**Comments on September 2013 Bechtel Phase 2 Final
Technologies Assessment for Alternative Cooling
Technologies at Diablo Canyon Power Plant**

November 19, 2013

Commissioned by Friends of the Earth

Dr. Peter Henderson and Dr. Richard Seaby
PISCES Conservation Ltd
Lymington, England

Figure 5. TetraTech Candidate Areas on Diablo Canyon Site for Cooling Towers²³

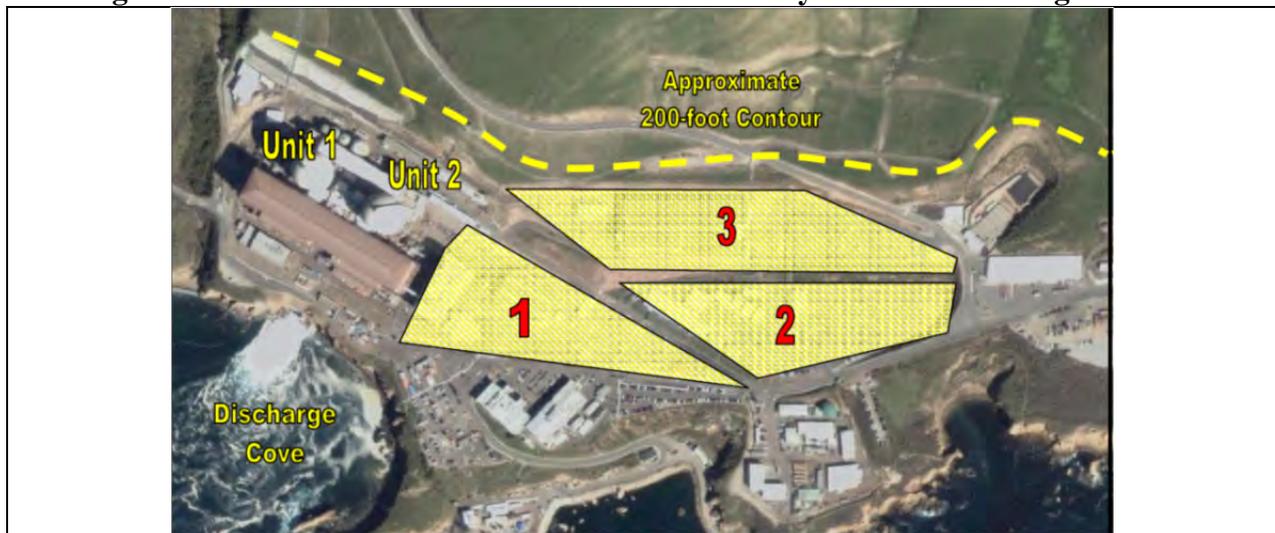
TetraTech identified three viable areas for siting cooling towers on developed land to the immediate east of Diablo Canyon Units 1 and 2 as shown in Figure 5. Some removal or relocation of existing structures would be necessary with the proposed TetraTech cooling tower design as shown in Figure 5. TetraTech states that:

Figure 6. Location of Back-to-Back of Cooling Towers Evaluated by TetraTech

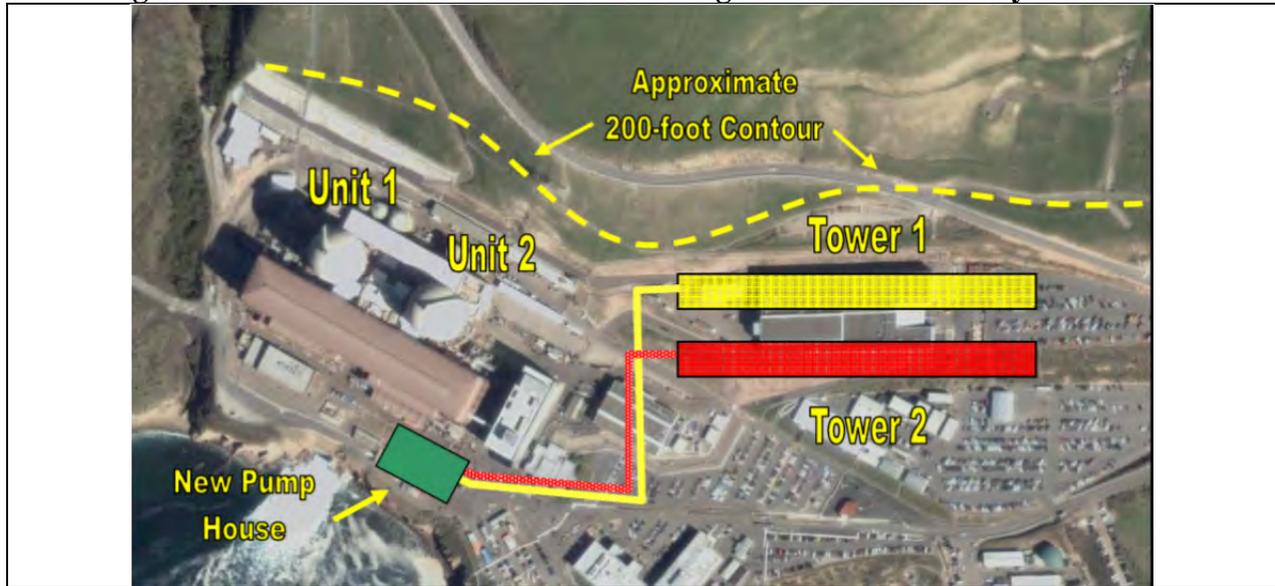
TetraTech evaluated two 52-cell back-to-back conventional mechanical draft cooling for Units 1 and 2 at Diablo Canyon as shown in Figure 6. Each cooling tower would be 1,404 feet long by 108 feet wide by 59 feet tall. TetraTech assumed that each cooling tower would be one continuous 1,404 feet long unit. This assumption overly limited cooling tower siting possibilities.

There is sufficient space to site back-to-back cooling towers with minimum impact on the existing main warehouse (Area 3) and temporary buildings (Area 2) if the cooling towers are each split into two equivalent 22-cell sections, or two sections that sum to 44-cells per cooling tower. PG&E, in its conceptual cooling tower plan for Diablo Canyon, split the back-to-back cooling towers into two equivalent sections (see discussion of PG&E cooling tower conceptual plan in this section).

Figure 7. Potential Layout of ClearSky™ Cooling Towers TetraTech/PG&E Location

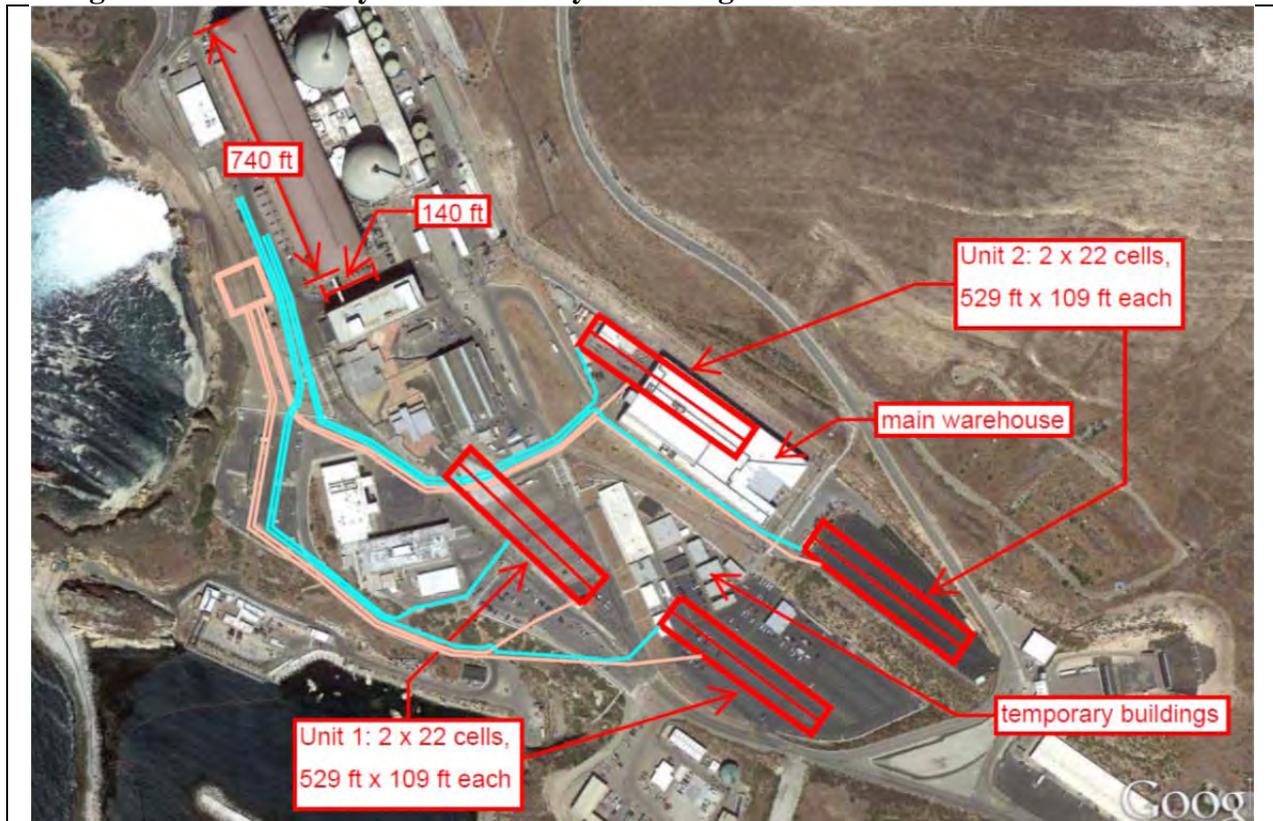
Adjusting the 62-cell, 12 °F design approach temperature SPX salt water cooling tower to a 17 °F design approach temperature results in 44-cell salt water cooling towers for Unit 1 and Unit 2. These cooling towers would be constructed in two sections each as shown in Figure 6. Splitting the cooling towers into two sections allows much more effective use of available space at Diablo Canyon. It also minimizes the potential for recirculation of warm air exiting the cooling towers by increasing the spacing between tower sections. A potential layout at Diablo Canyon for the two 44-cell cooling towers configured in two 22-cell sections each is shown in Figure 7.

Figure 8. Unit 1 Cooling Tower Composed of 2×9 and 2×13 Sections

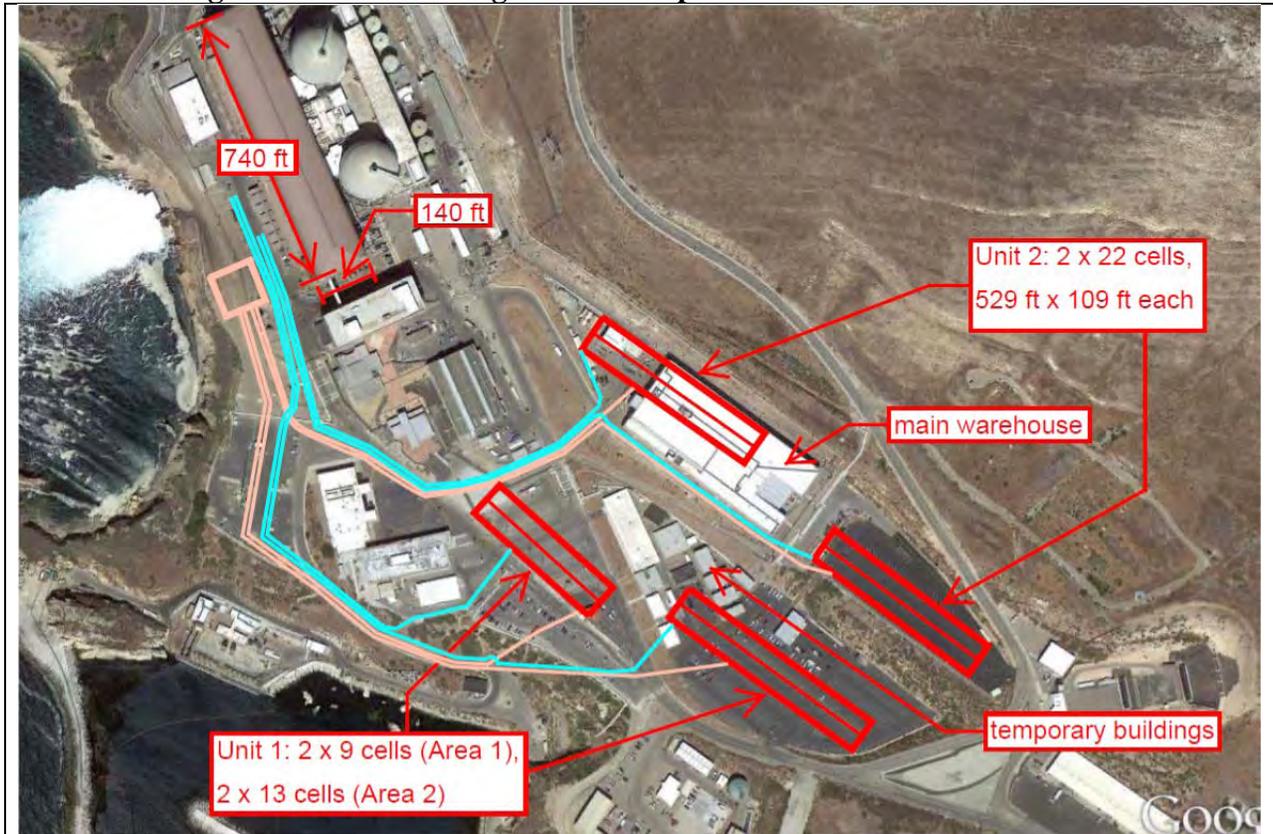
The potential arrangement for the Unit 1 cooling tower sections shown in Figure 7 above could also be modified to take advantage of the greater amount of space available in Area 2 than Area 1 for the cooling tower sections. Only temporary buildings would be displaced in Area 2 by the Unit 1 cooling tower section. A 9x2 cooling tower section in Area 1 would provide an additional buffer between buildings in Area 1 and the Unit 1 cooling tower section. A 2x13 cell Unit 1 cooling tower section would be located in Area 2. See the Unit 1 cooling tower configuration in Figure 8. The Unit 1 cooling tower would remain a 44-cell back-to-back plume abated tower. The capacity of the dedicated circulating water pumps and associated pipelines serving each of the two Unit 1 cooling tower sections would be adjusted to meet the flowrate and hydraulic head requirements specific to each section of the Unit 1 cooling tower.

Figure 9. Layout of 40-Cell Back-to-Back Cooling Towers Evaluated by PG&E³⁰

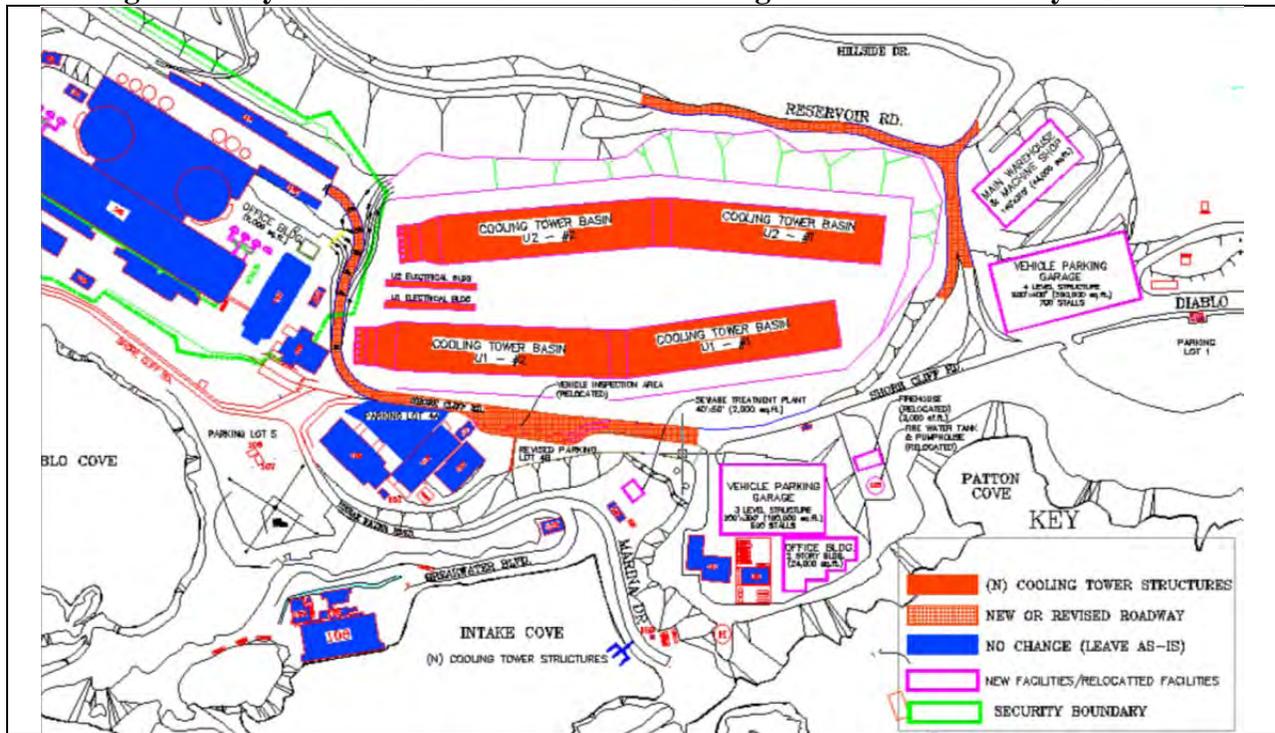
PG&E evaluated back-to-back mechanical draft cooling towers for Diablo Canyon in 2011, using cooling towers similar to those assumed by TetraTech in its 2008 study.²⁹ The PG&E cooling towers consist of 40-cells for each unit, in two sections of 20 cells each, located in the existing warehouse and parking areas to the east of the reactors. This is the same area where TetraTech located the cooling towers in its 2008 study. The layout of the cooling towers evaluated by PG&E is shown in Figure 9.

Figure 10. Location of Cooling Towers Evaluated by Bechtel³³

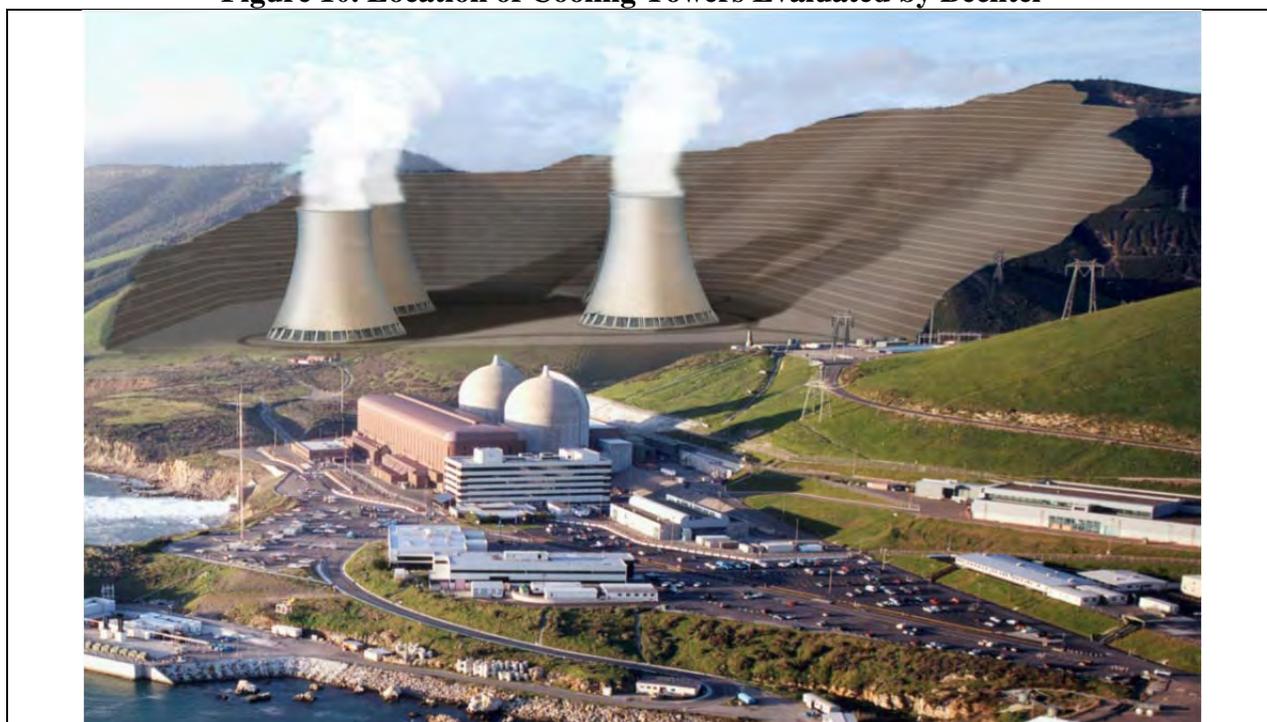
In contrast, Bechtel evaluated several different cooling tower designs away from the main plant site on (currently) steep terrain east of a 47-acre archaeological site.³¹ Bechtel provides no explanation in its report as to why it selected this site instead of other possible sites on the property. Bechtel identified the preferred design as natural draft hyperbolic cooling towers on a mountainous site requiring the removal of over 317 million cubic yards of rock and overburden.³² Bechtel makes no mention in its report of prior Diablo Canyon closed cycle cooling studies, such as those prepared by TetraTech and PG&E, that selected salt water back-to-back mechanical draft cooling towers and located these towers in the developed area to the east of the reactors. The proposed cooling towers and their location are shown in Figure 10.

It is important to note also that the cooling tower location(s) selected by Bechtel is significantly closer to the Diablo Canyon switchyard than the alternative cooling tower location in the existing Diablo Canyon parking lots. This spatial relationship is shown in Figure 11. The closest Bechtel cooling tower is about 1,500 feet from the edge of the switchyard. The closest back-to-back cooling tower in the alternative parking lot location is about 2,200 feet from the edge of the switchyard. In addition, the Bechtel tower locations are at the entrance to the ravine where the switchyard is located. In contrast, there is a ridgeline separating the alternate parking lot cooling tower location from the switchyard.
